MJ11/MM11

TECHNICAL
INFORMATION
DEC CONFIDENTIAL

EP-MJ11-00-TI-A

JAN 1977

D-IC-MM11-E-09

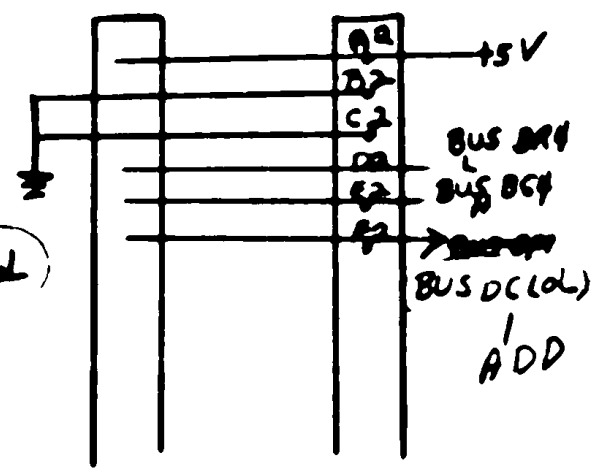
- INSTALL WIRES.
- CORRECT PRINTS.
- NOTE: IF INSTALLATION OF THIS UNIT CREATES A MULTIPLE BOX SYSTEM, THIS ECO AND ECO NUMBER 5408475-00006; ECO NUMBER M930-00001 MUST BE INSTALLED. ONE SET OF CONNECTIONS BETWEEN THE POWER BUS AND UNIBUS ARE REQUIRED FOR EACH BALL WITHIN A SYSTEM.

ECO# MM11E-00016 D-AD-7006468-0-0

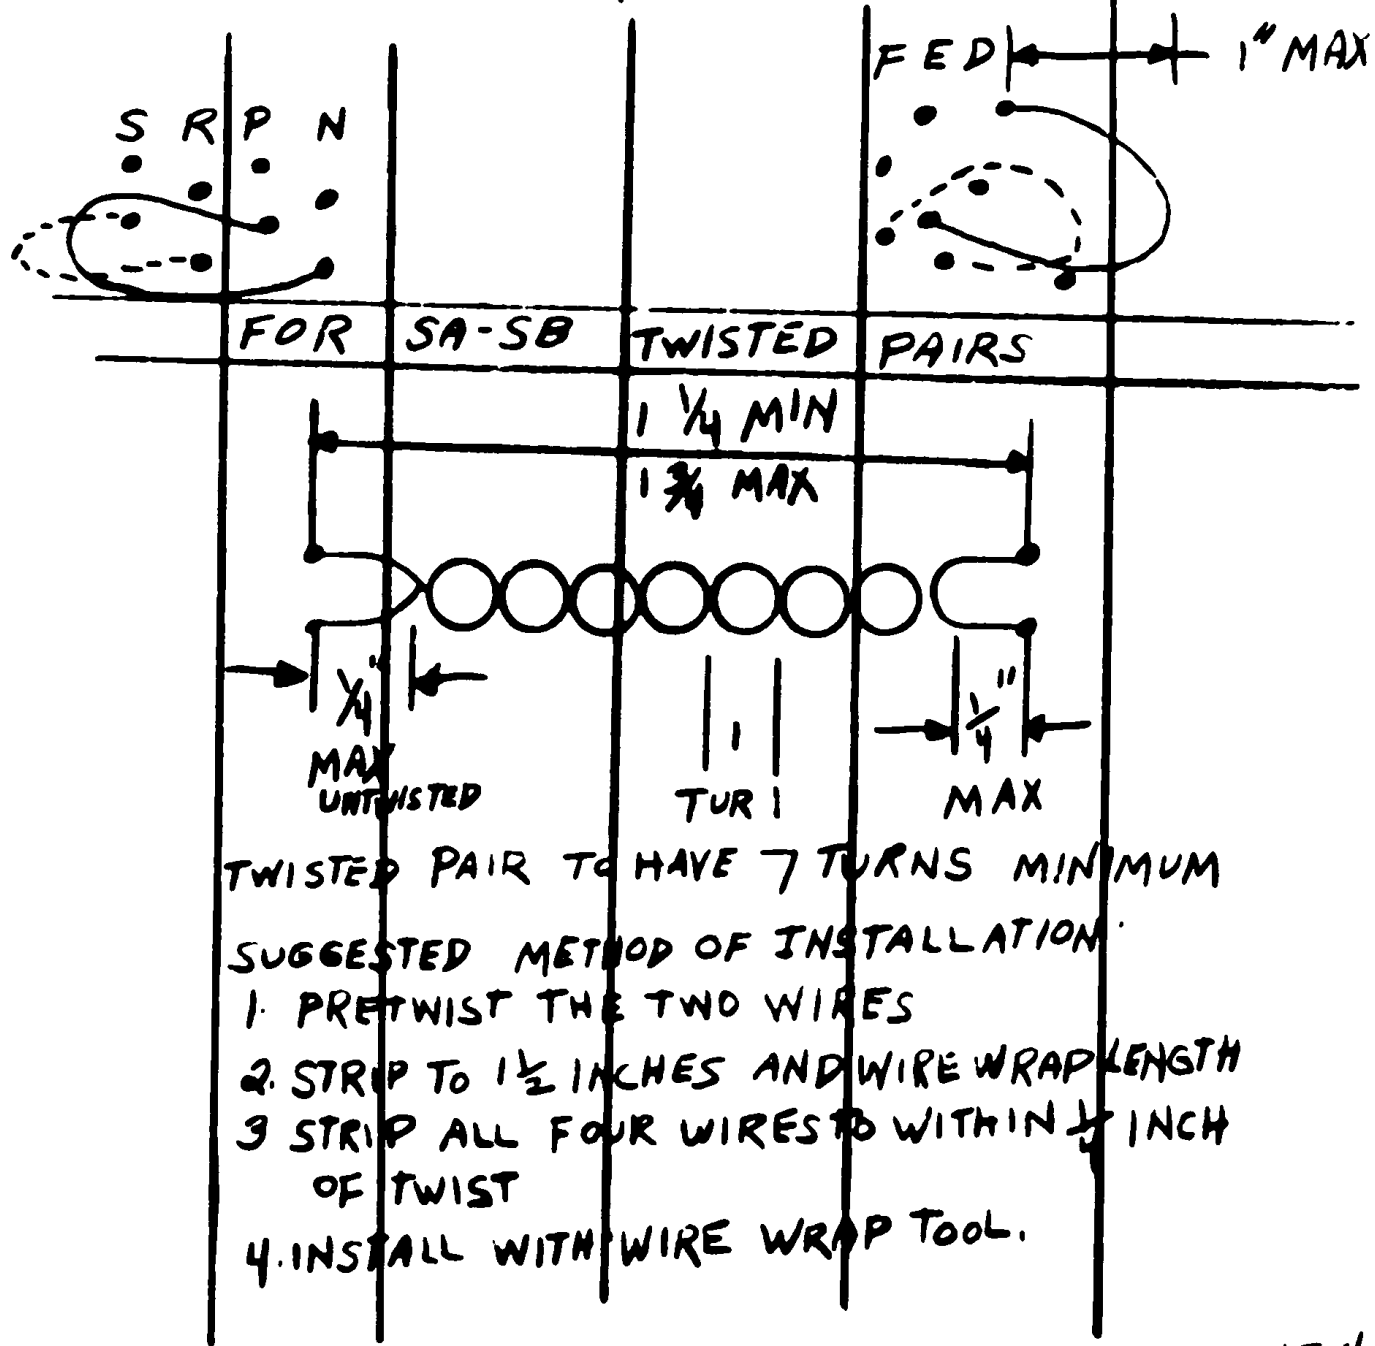
- TIMING + FLOW DIAGRAM WPONG.
- NOT ENOUGH INFORMATION GIVEN ON THE DRAWING TO INSURE THE REQUIRED RESULTS WHEN HAND WIRE. WRAPPING. TWISTED PAIRS WILL PICK BACK PLANE NOISE UNLESS DONE CORRECTLY.

LENGTH SHOULD BE A MAXIMUM OF
 $2\frac{1}{4}$ INCHES. CHECK DRAWING FOR
 LENGTH AND FOR HOW LOOPS SHOULD
 BE DRESSED INTO LOGIC.

- CORRECT TIMING + FLOW DIAGRAM
- ADDITIONAL INFORMATION PUT ON THE PRINT.

0-BS-MM11-E-05

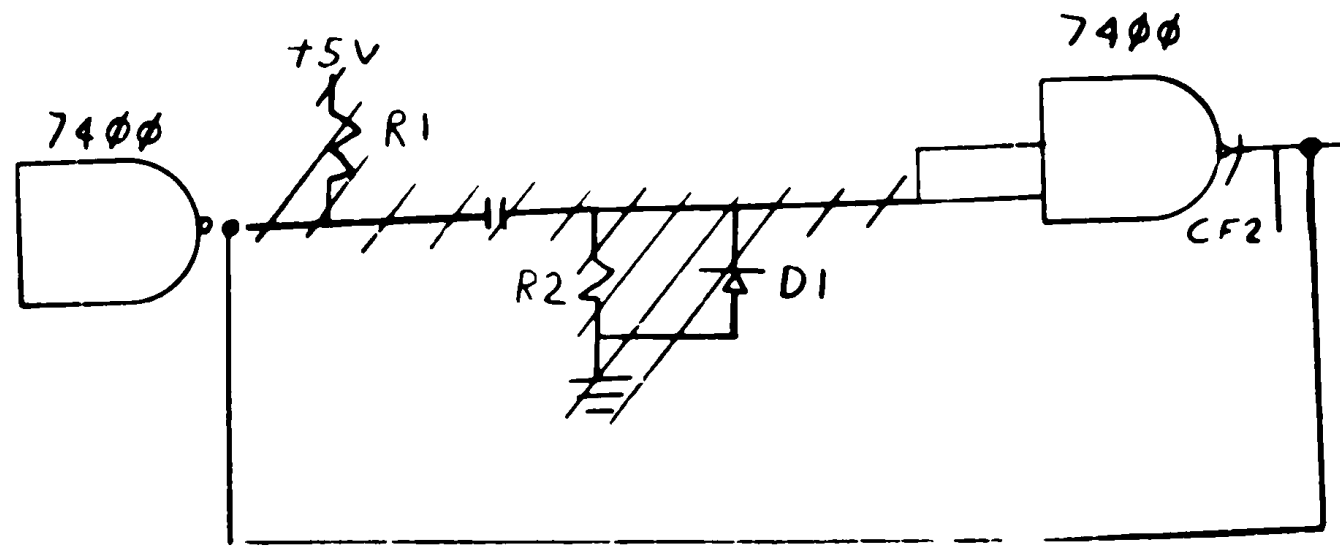
1. CHANGED TEST PROCEDURE TO IMPROVE MEMORY PERFORMANCE.
2. CORRECT WIRE LIST ACCORDING TO SUBMITTED ADD/DELETE SHEET.
3. UPDATE BLOCK SCHEMATIC PER ATTACHED MARKED UP PRINT.
4. UPDATE TIMING AND FLOW DIAGRAM AS INDICATED.
5. REMOVE WRITING FROM MARGIN.

digital	COMP. MEMORY STACK (X DRIVE)	ENG NO. D-05-MM11E-03	REV B
	ENGINEER NO CHANGE ORDER	DATE 1/1/68	GRAPHIC DESCRIPTION

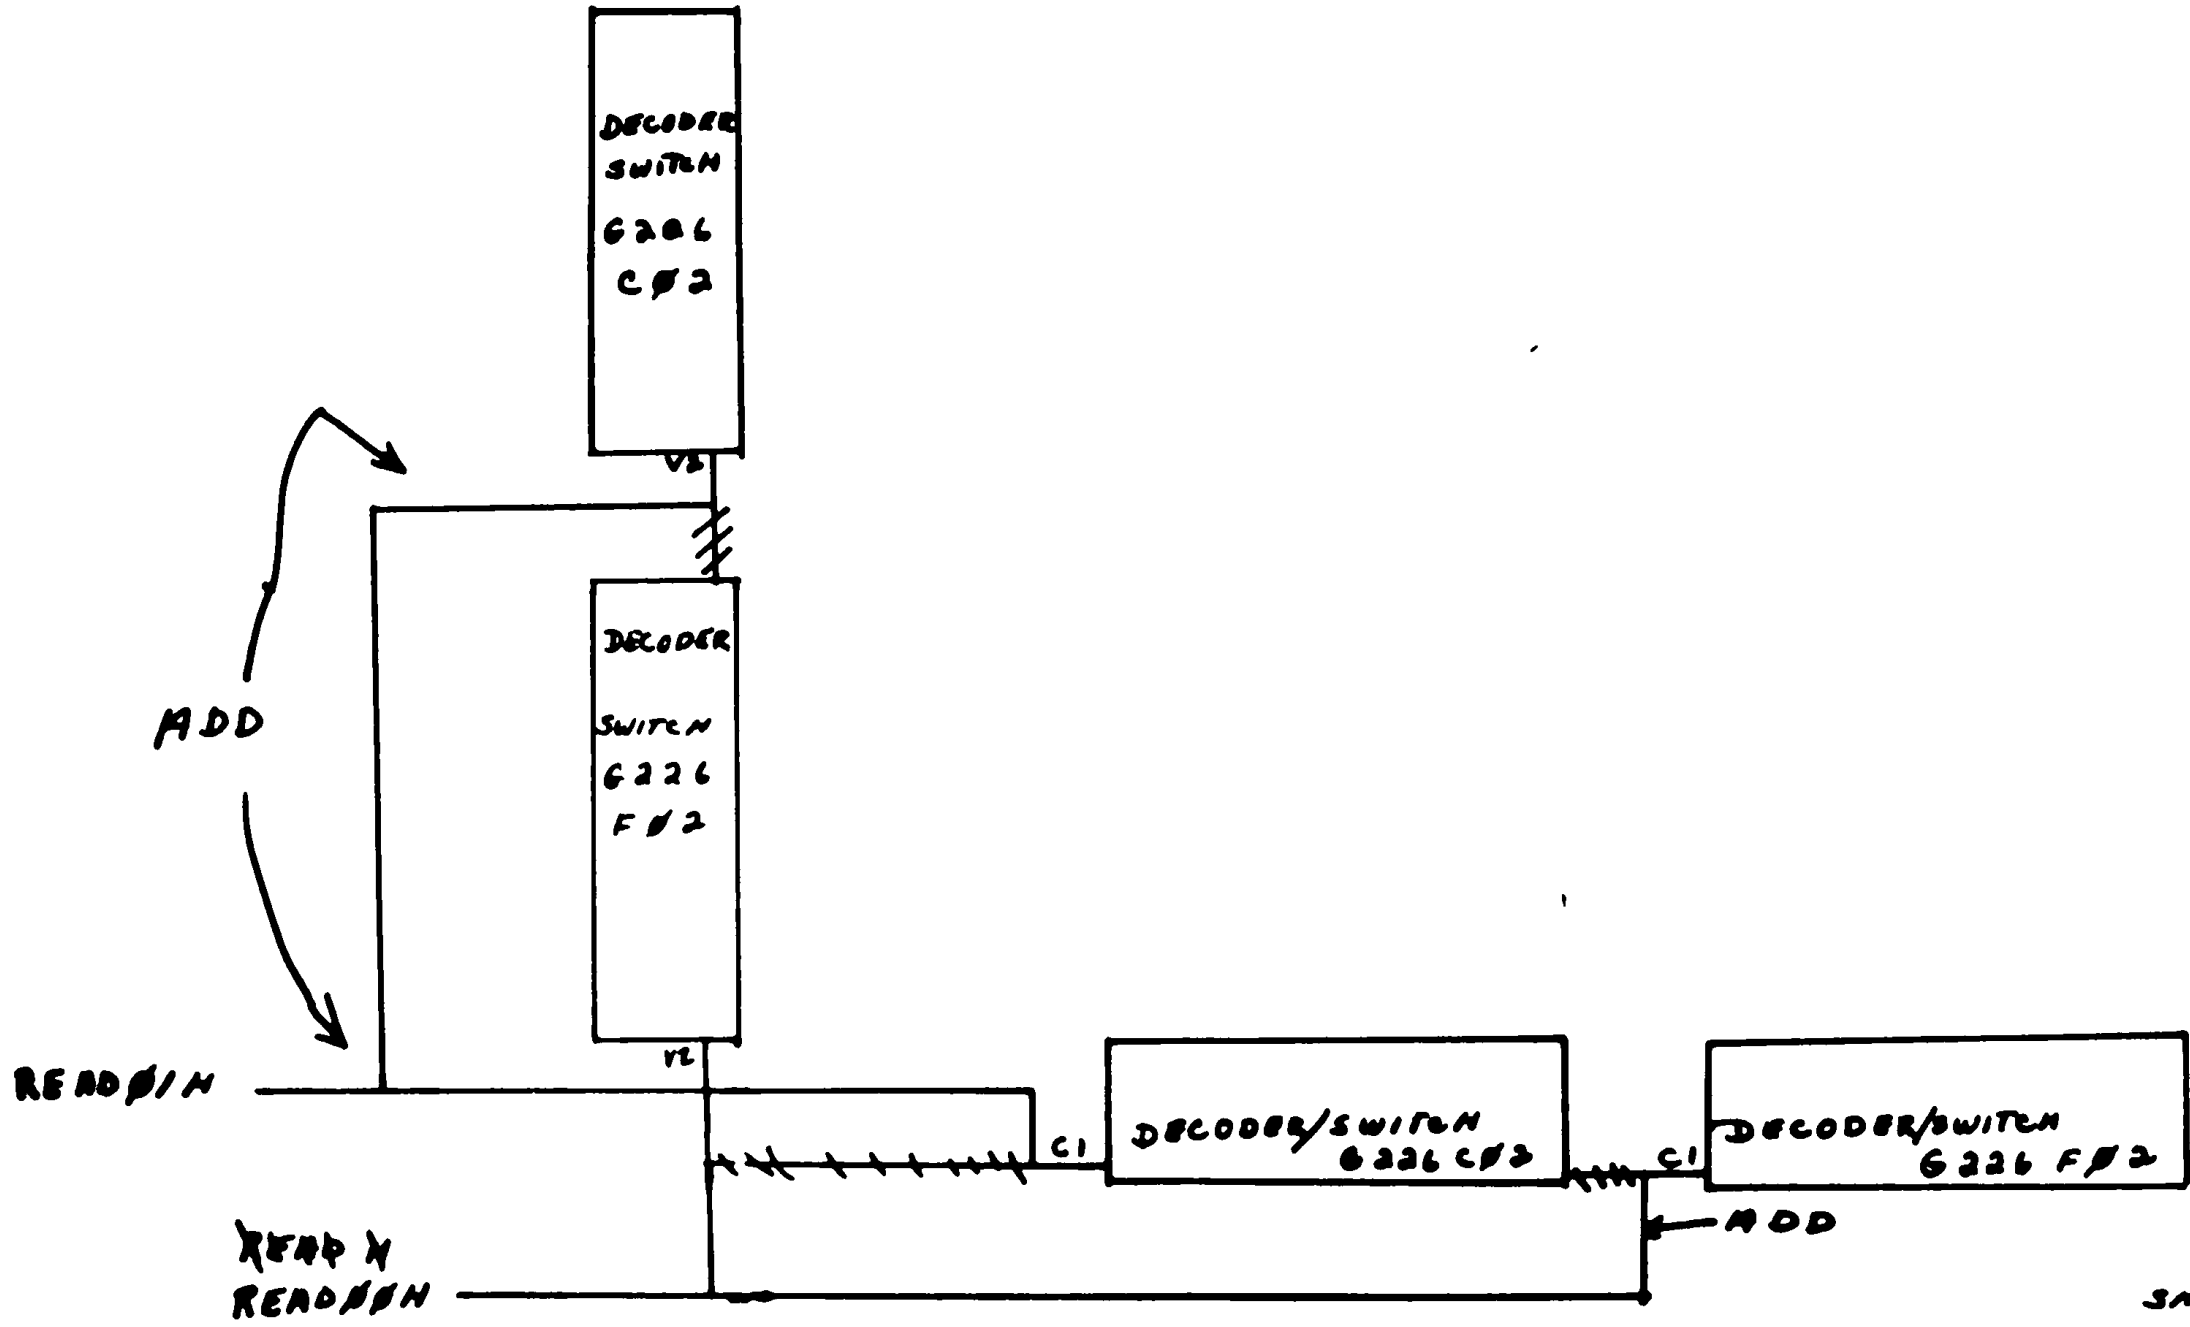
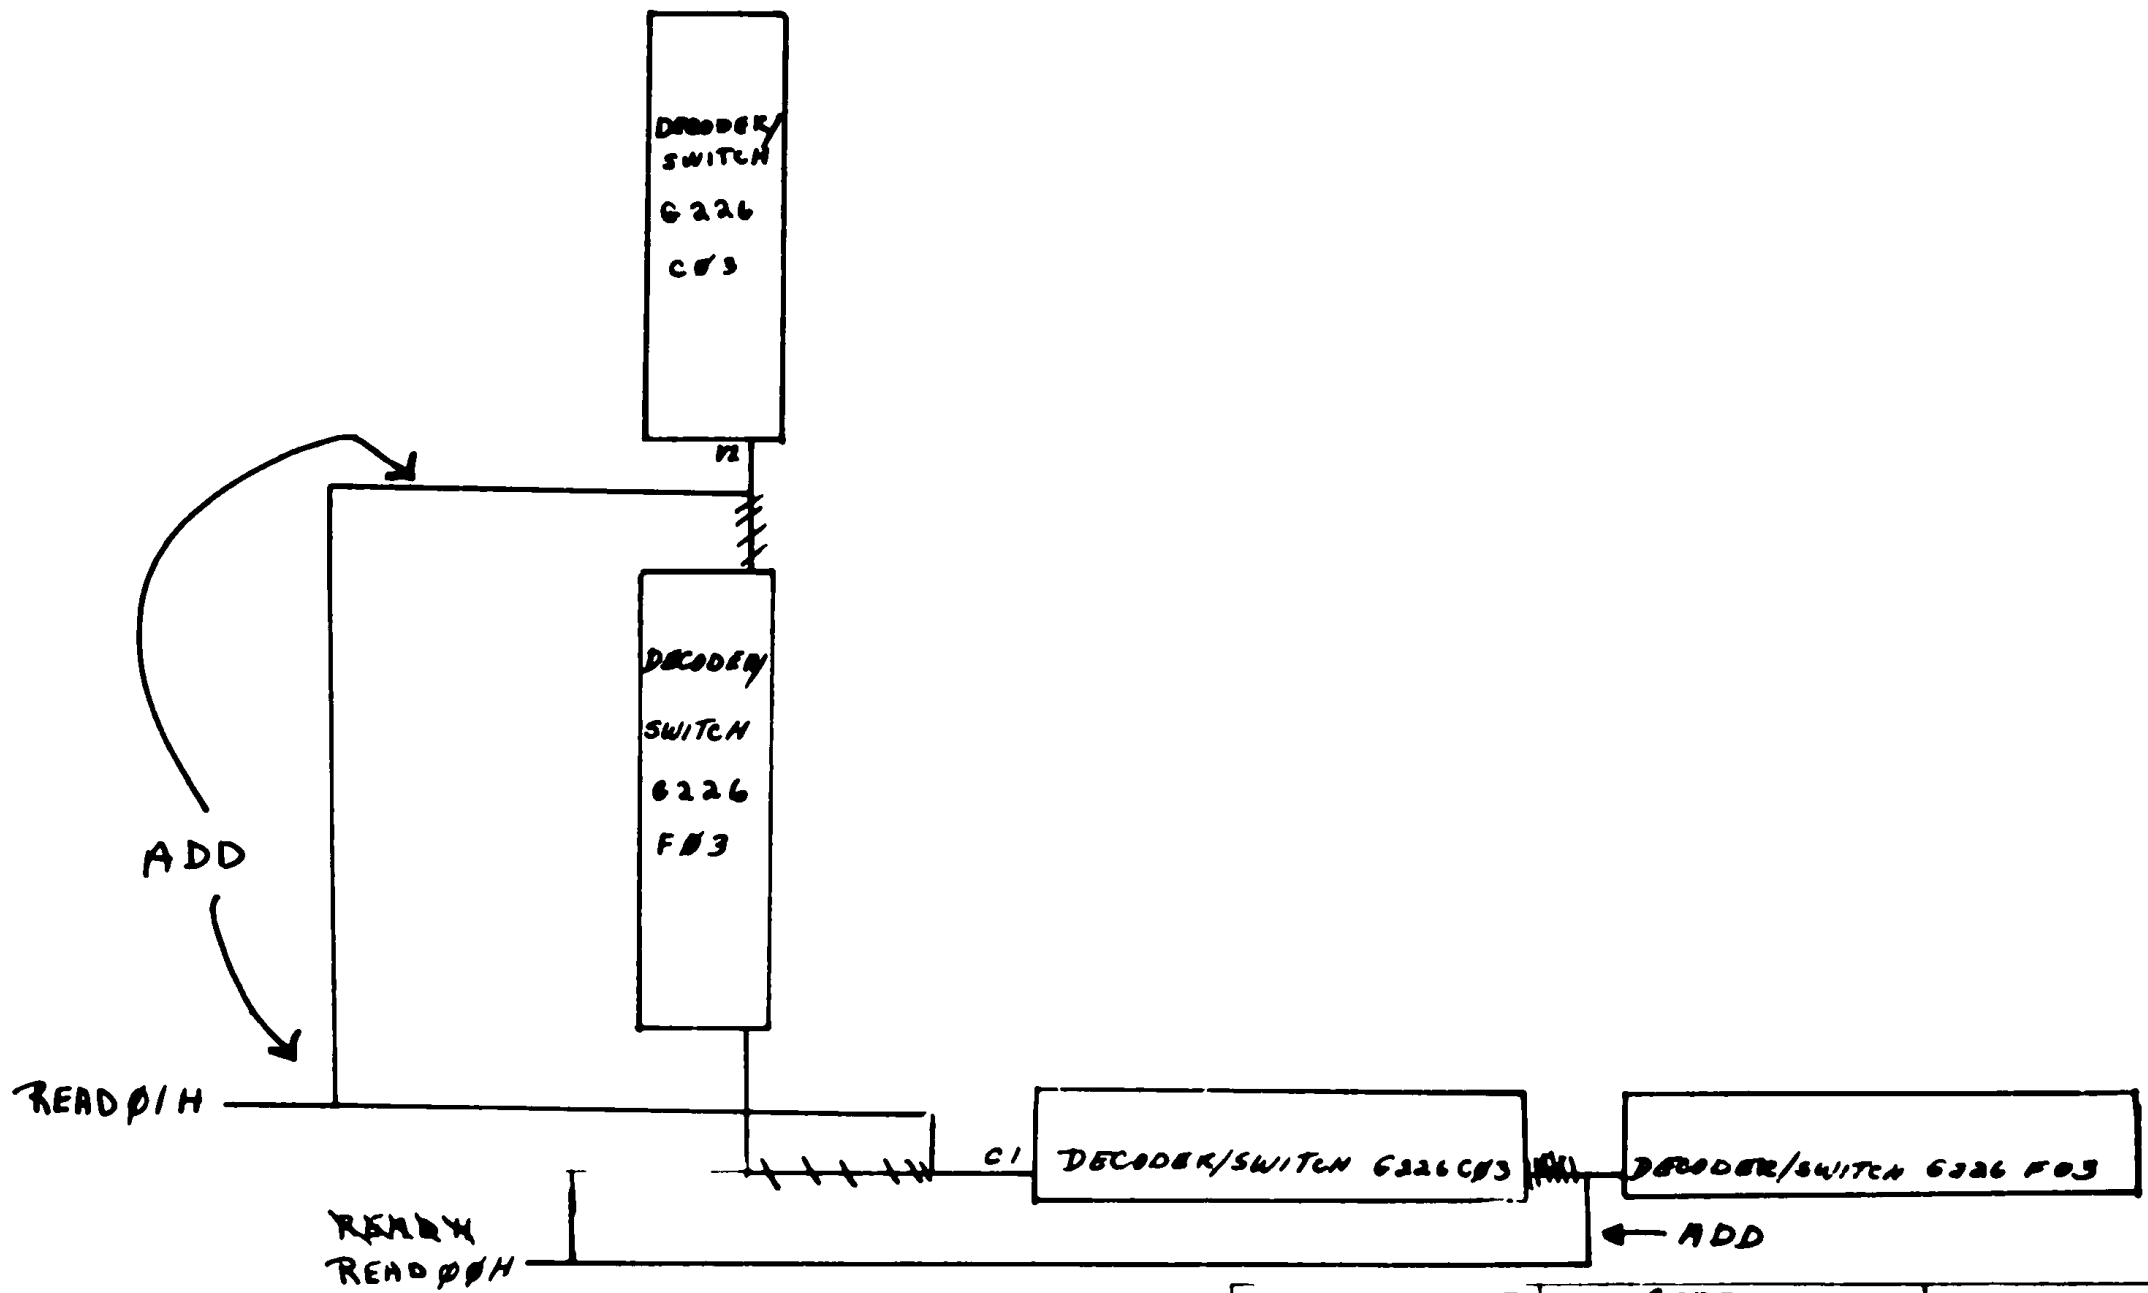
ITEM NO	DOCUMENT/PART NO	OLD REV	NEW REV	DISP CODE	DESCRIPTION OF CHANGE
1	K-WL-MM11-E-07	D	E	06	Wire List Update
2	D-AD-7006468-0-0	D	E	06	Wire Ass'y MM11-E See final release print.
3	D-BS-MM11-E-03	A	B	06	Core Memory stack (2 sheets) See final release print.
4	A-ML-MM11-E	Z	AA	06	UPDATE REV PER THIS ECO.
5	E-DI-MM11-E-01	E	F	06	UPDATE REV PER THIS ECO
6	A-PL-7006468-0-0	D	E	06	UPDATE REV PER THIS ECO.
